INDESIT company

MTM1522VR/HA

F048064

Exploded views

51720G0 Exploded views

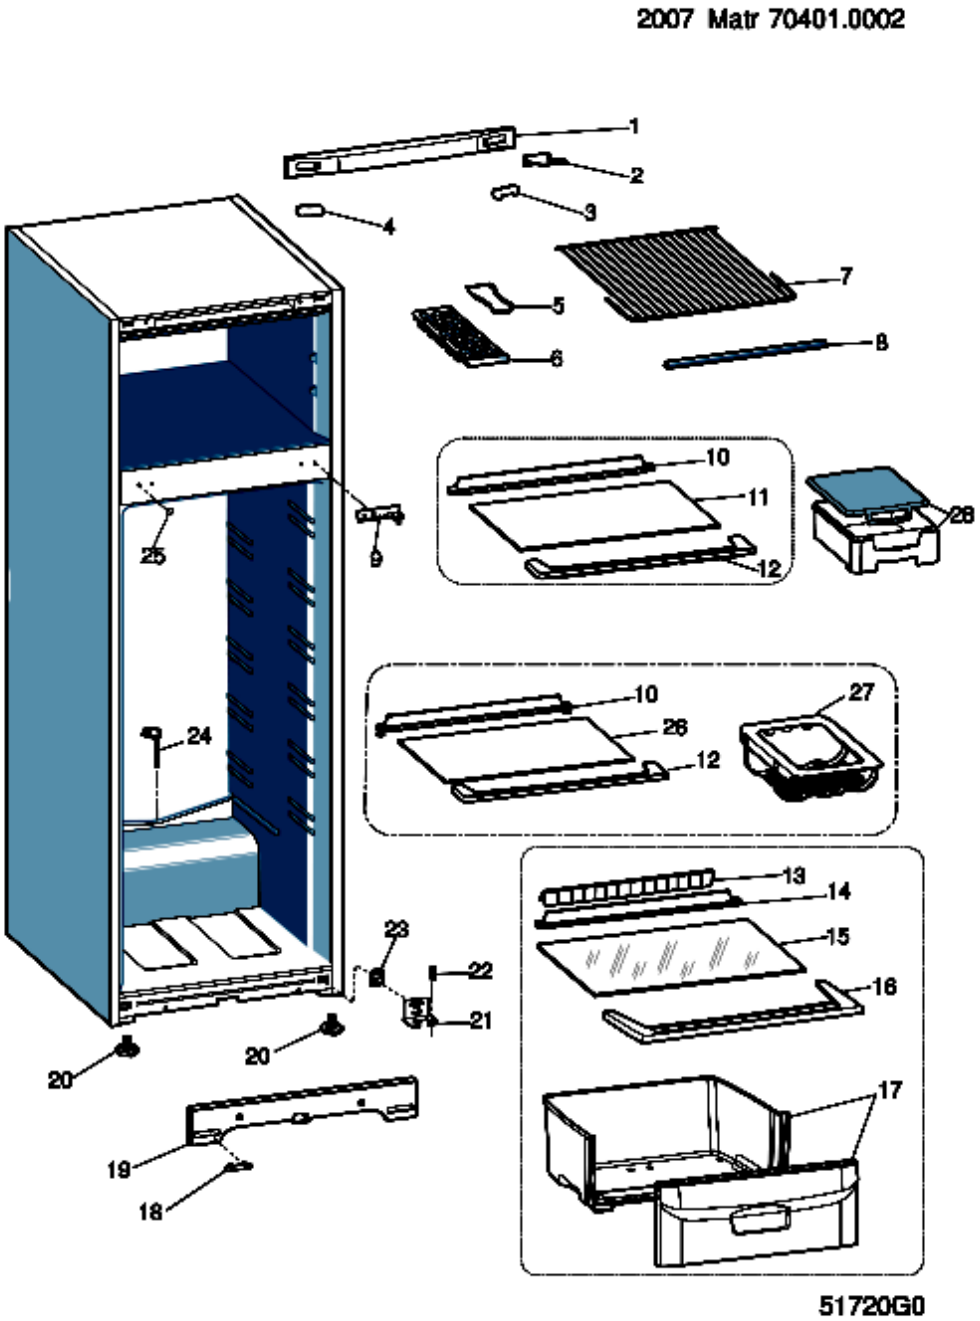
n2510j00: SUBSTITUTION LOWER HINGE PIN

In order to make better the assembly and to prevent an accidental unscrewing of lower hinge pin with consequent falling down of the door, original pin has been substituted by another one longer.

In the course of the time more than one pin has been tested, therefore the history of the substitutions is reported:

C00017658 (13.5mm) --> C00259768 (21mm) --> C00281425 (23mm)

For quality issues on interested models is managed only the last one C00281425 (23mm).
